TECHNICAL BULLETIN

FAM-A-0010-A

Expansion of the Operating Ambient Temperature Range and Change of the External Appearance of FX5-CCLGN-MS

FX5-CCLGN-MS

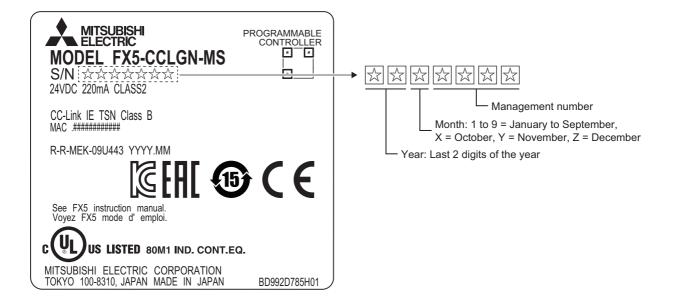
- The operating ambient temperature range will be expanded. (The range will be changed from -20 to 50°C to -20 to 55°C.)
- To make it easier to install/remove the module, the shape of the joint part on the module side will be changed.

Item	Before change	After change	
Operating ambient temperature	-20 to 50℃	-20 to 55℃	
Shape of the joint part on the module side		Notches are added.
